ADDENDUM NO. 1

**RE: Engineer's Project No.: 2025.032
American Tobacco Trail Drainage Improvements**

**GRADING & DRAINAGE
SITE 1
MILE MARKER 17.50**

GRADING & DRAINAGE
 SITE 4
 MILE MARKER 20.00
 3" CL.

Drawn By: **YTM**
 Checked By: **WSN**
 Sheet No.: **C1.0**

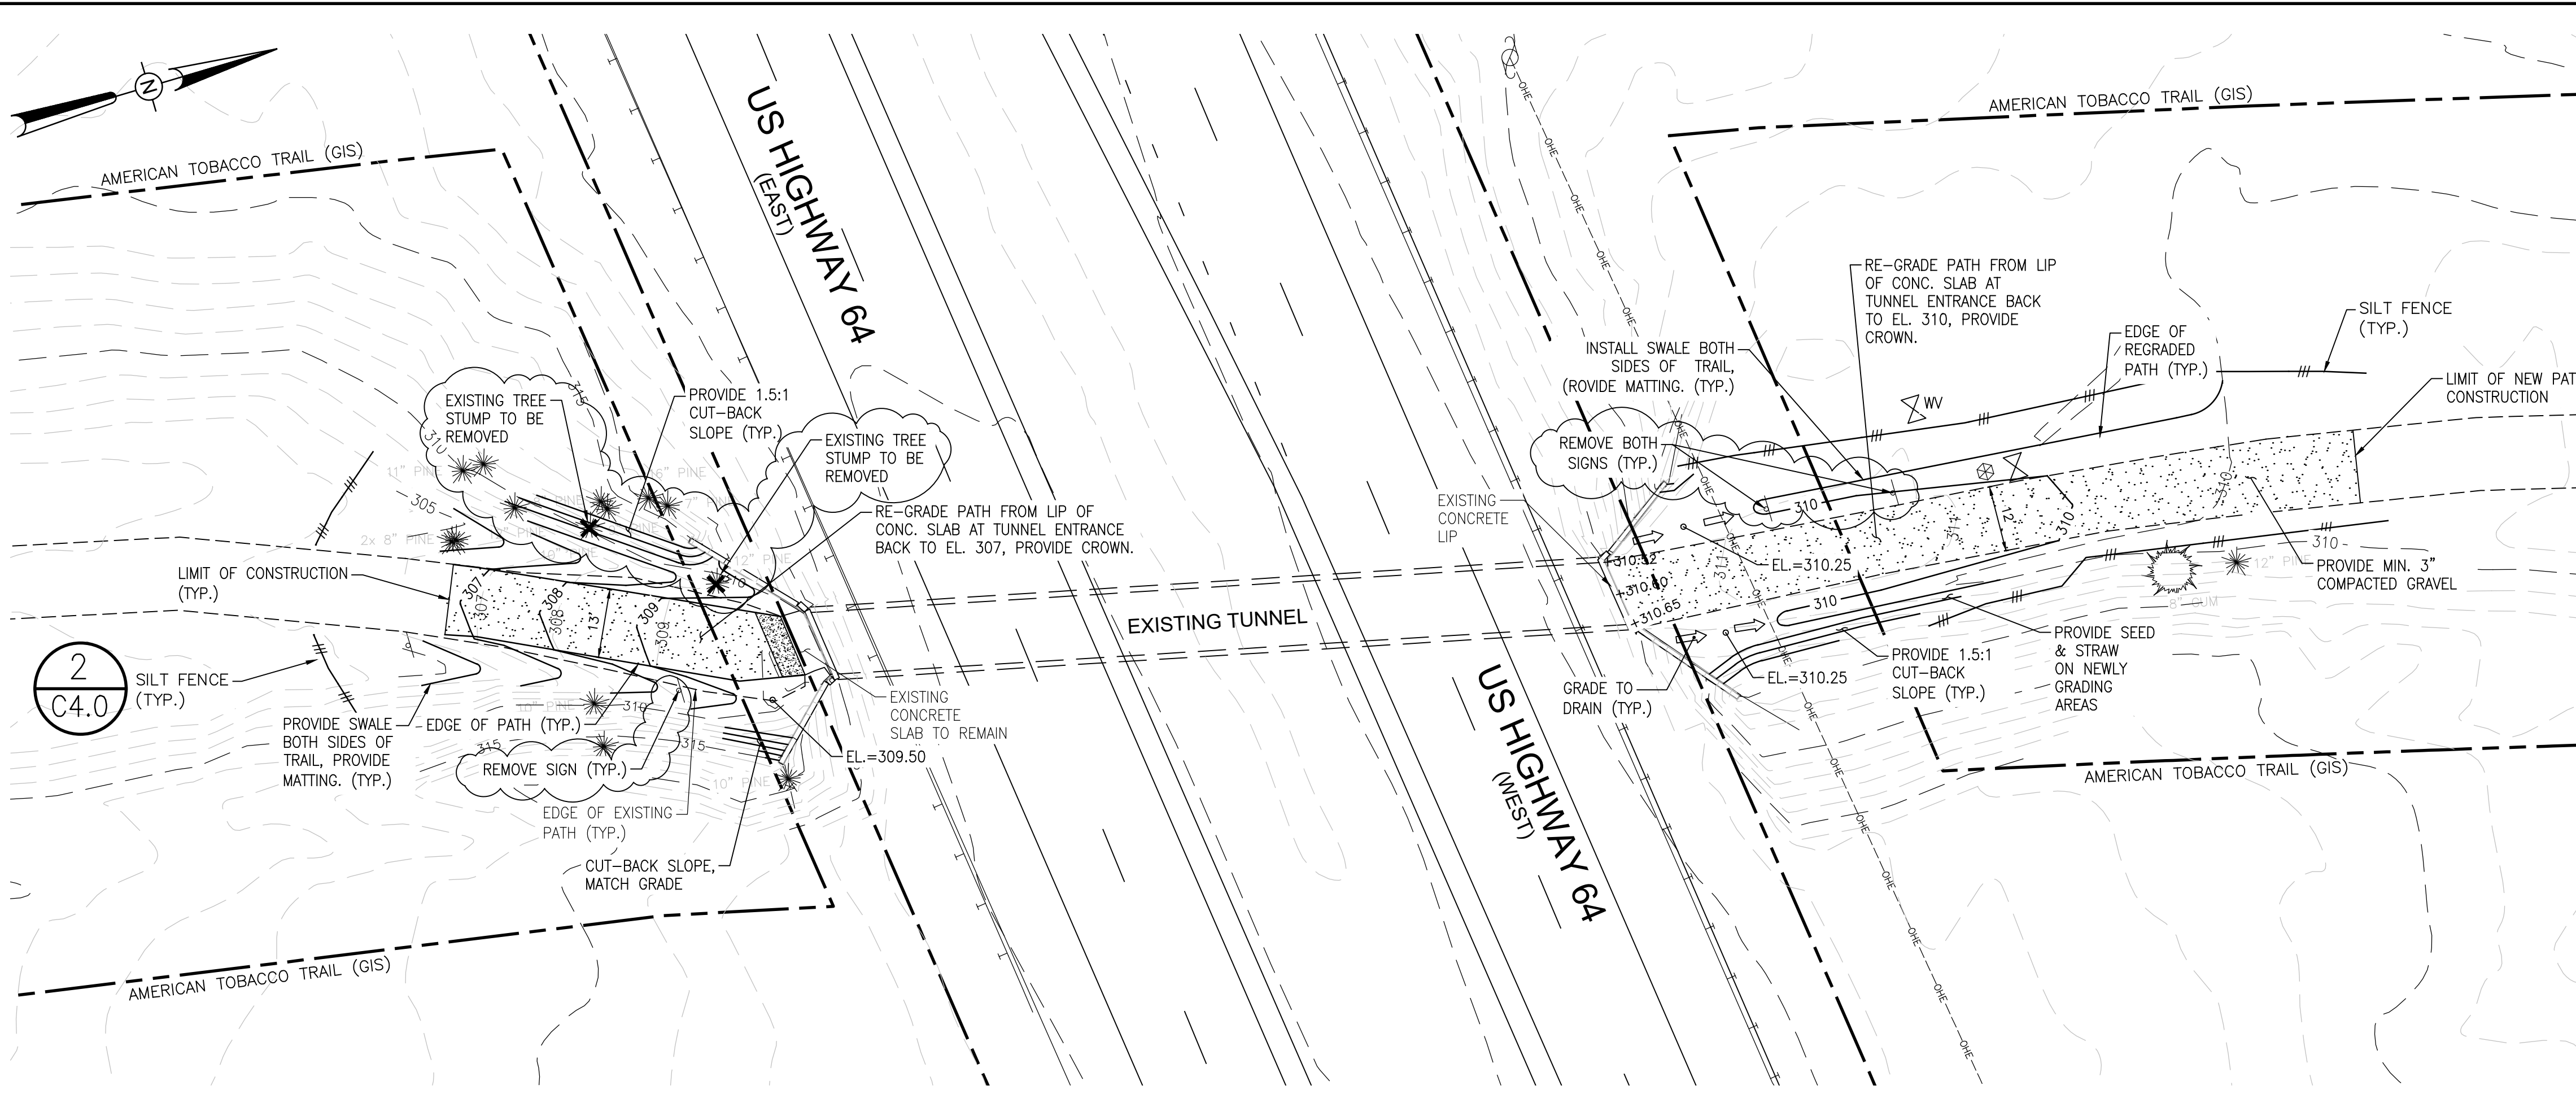
Plan sheet C1.0:

Site 1 (Grading & Drainage), there is a tree to be removed, including the roots, located between the Bathhouse Building and the Fountain.

SITE 4
 SCALE: HORIZONTAL 1" = 20'

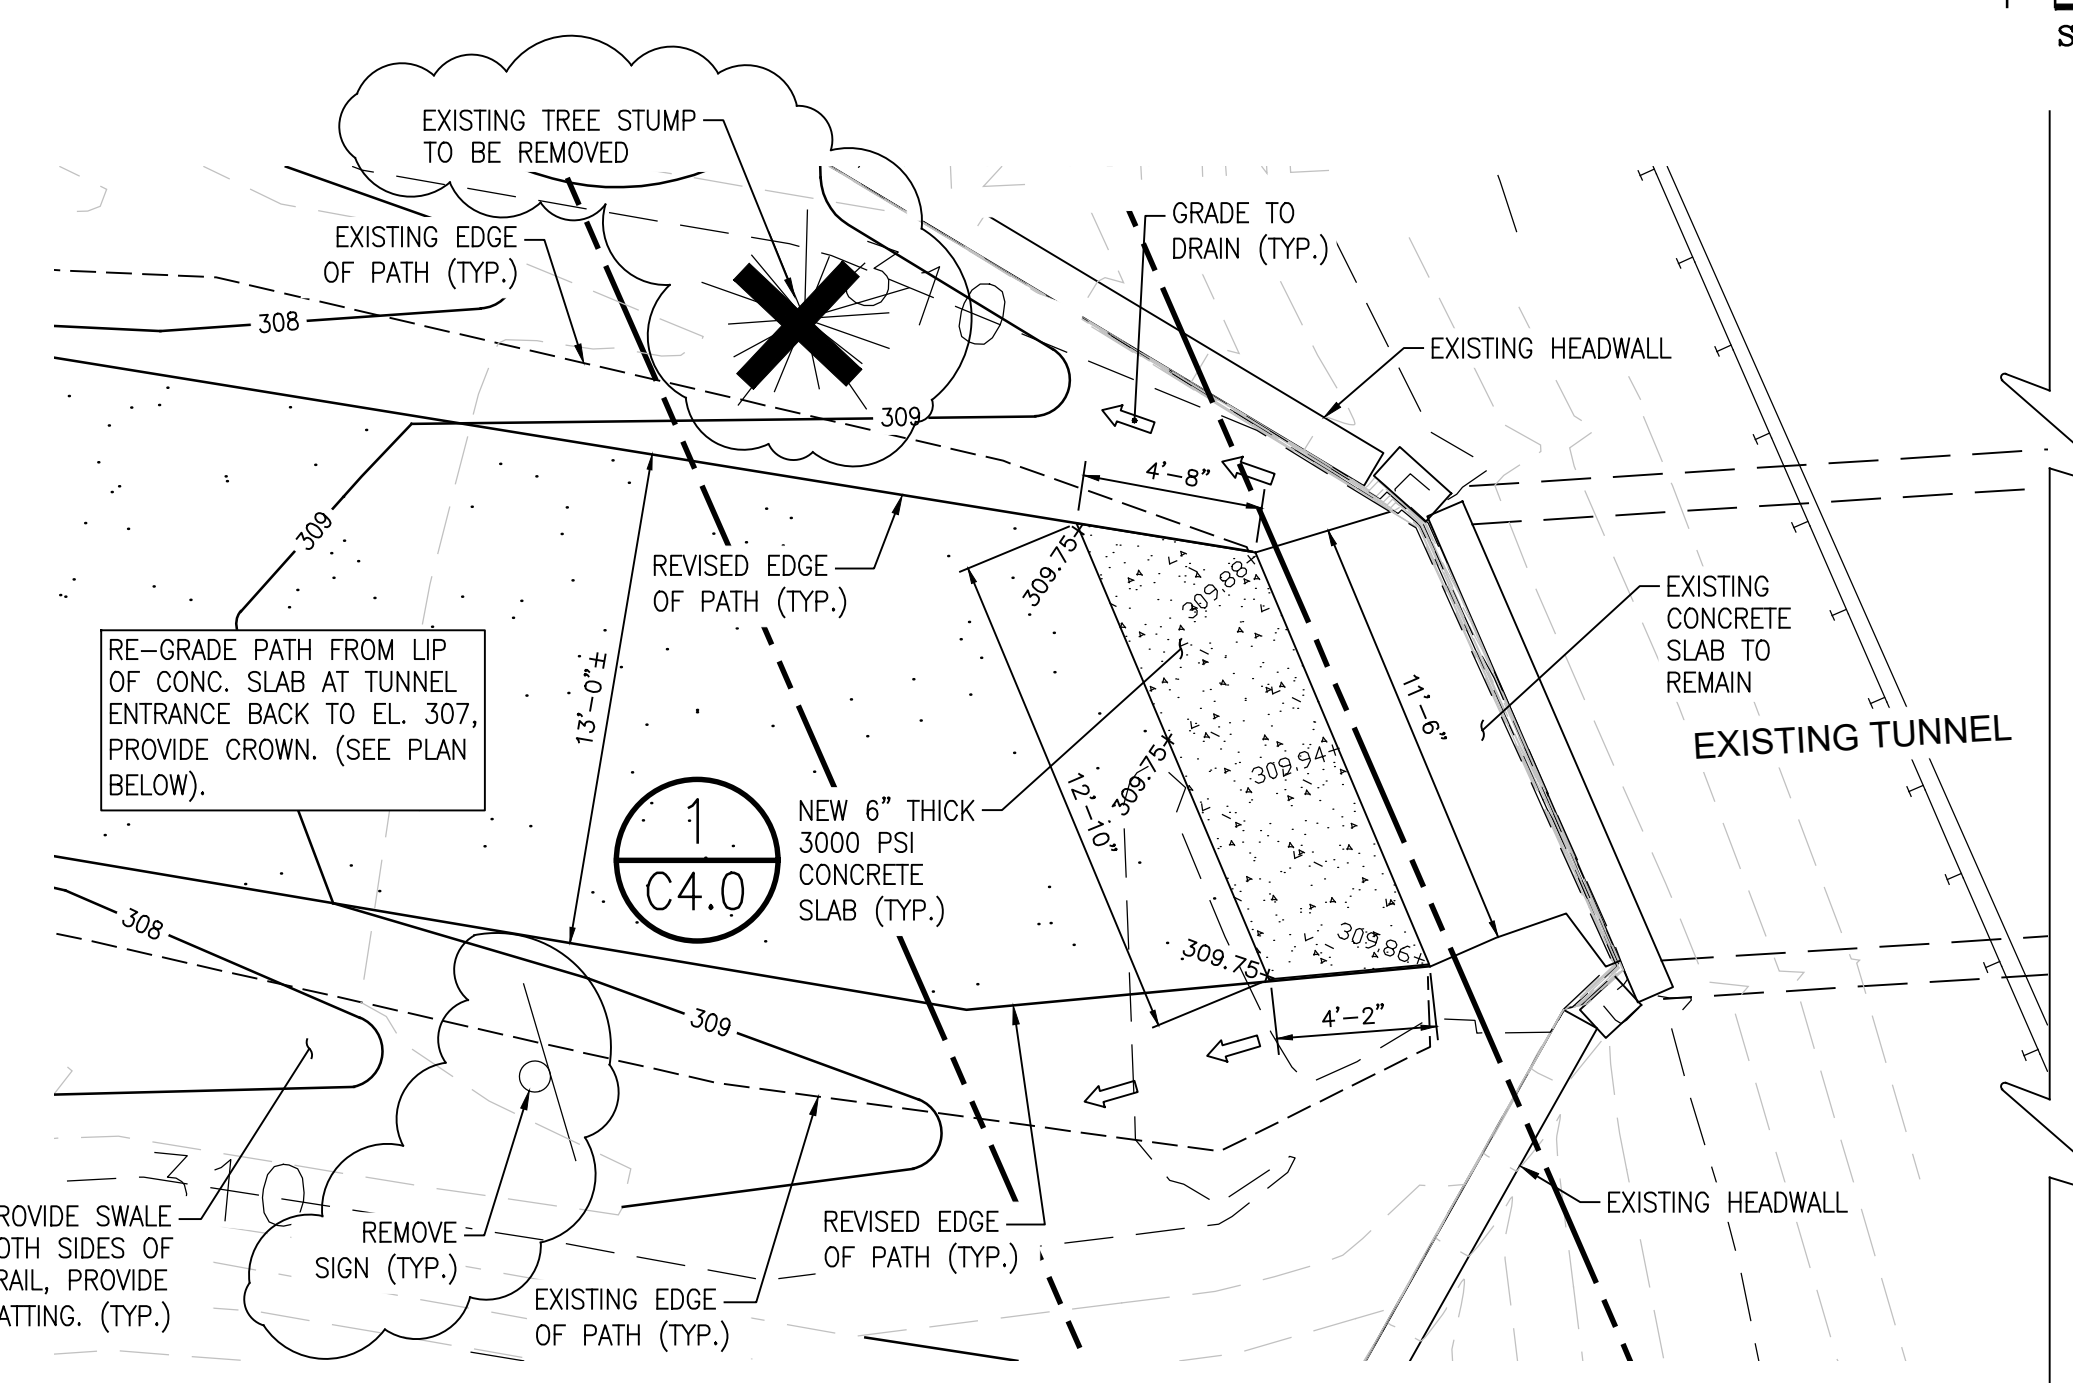
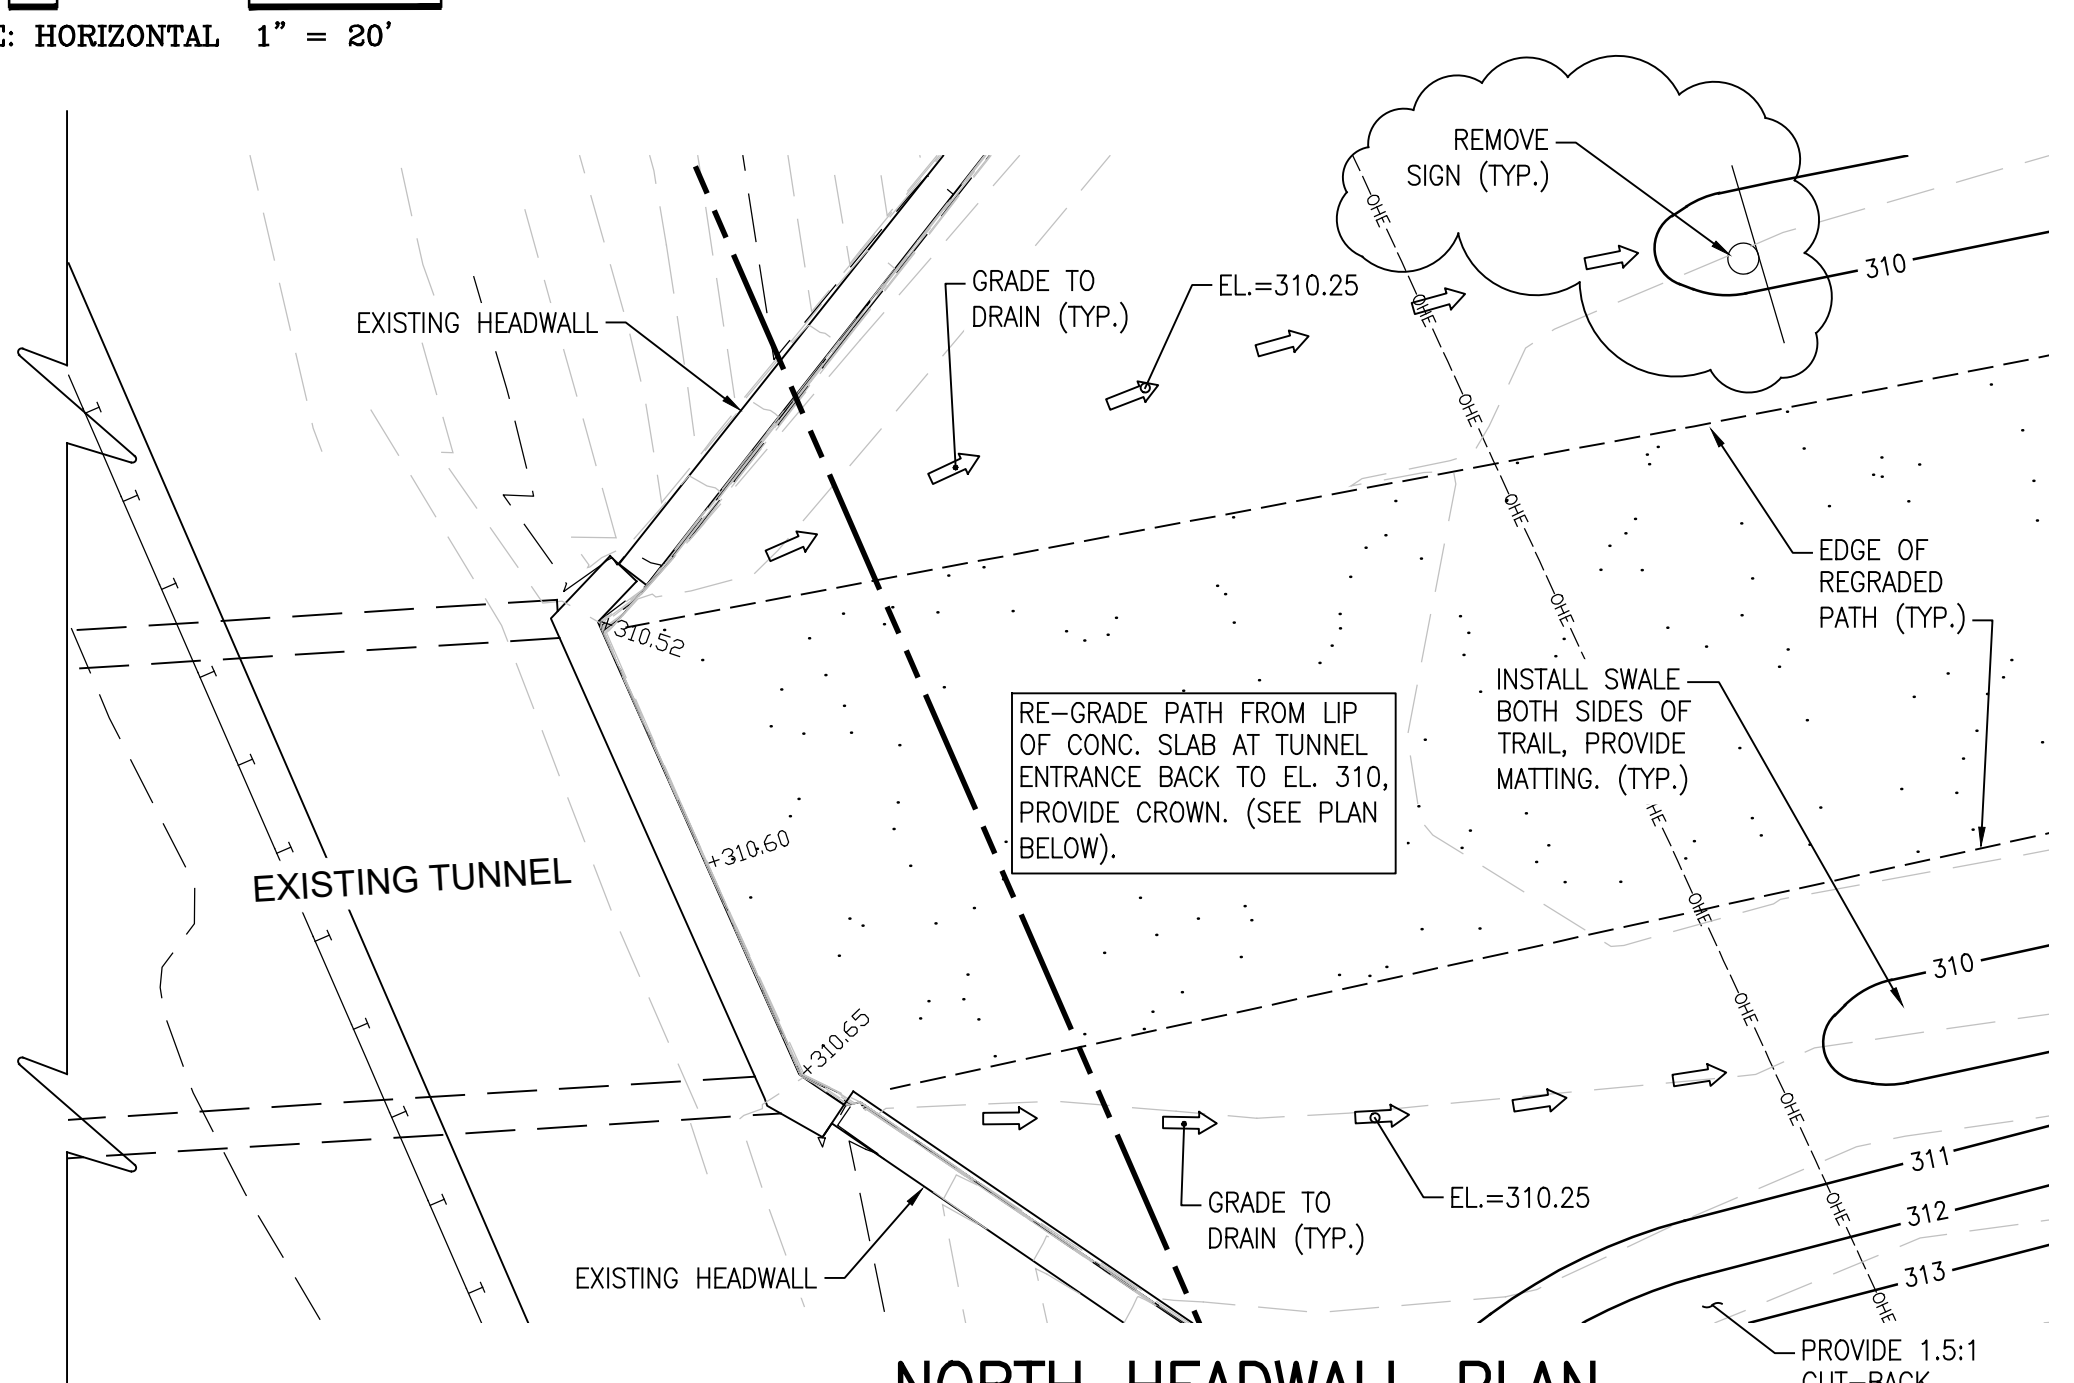
Plan sheet C4.0:

Site 4 (Grading & Drainage), there are no trees to be removed as NCDOT cut them down. There are just (3) stumps to be removed.

SOUTH HEADWALL PLAN
 SCALE: HORIZONTAL 1" = 5'

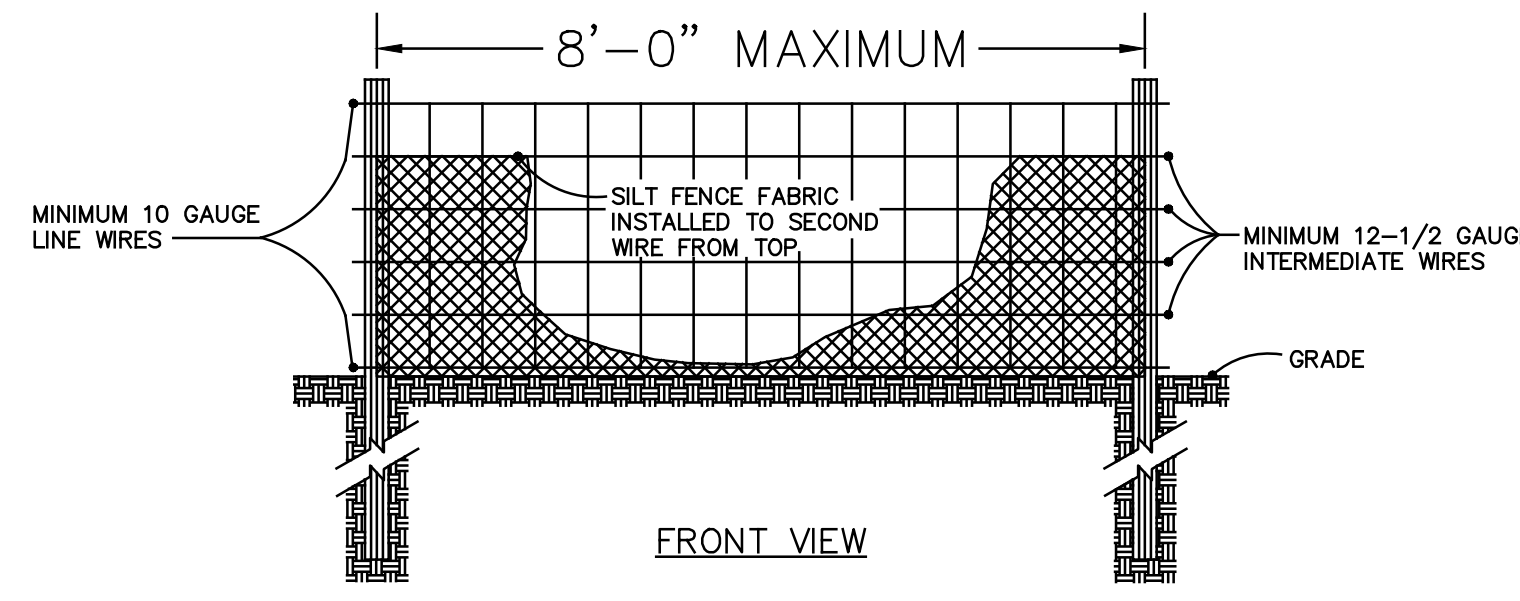
In South Headwall Plan: the existing sign shall be removed and delivered to the owner.
